Access Compliance Report Public Rights-of-Way (Pedestrian Signals)

ADA ID: 85BA5A0D15D2 Signal Type: One Push Button-Non APS **Overall Compliance: No** Severity Score: BTN 1:N/A BTN 2: N/A No BTN: N/A

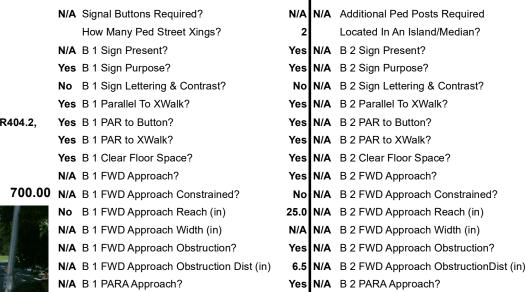
Possible Solutions: Replace Signal Push Button With APS Button on New Post. Remove & Replace Sign.

PROW/ADA: R410.6, TMUTCD 4e.08, R404.2, R406.2
